Prairie Island

NIS PR Bypass Test Panel License Amendment Request

August 11, 2021

#### **Proposed TS Markups**

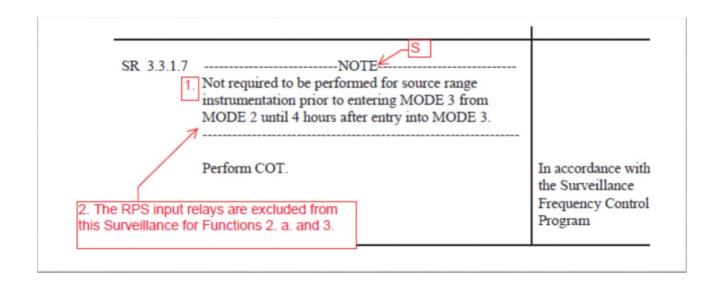
D. One Power Range Neutron Flux channel inoperable. The inoperable channel may be bypassed for up to 4 hours for surveillance testing and setpoint adjustment of other channels.

D.1.1 Place channel in trip.
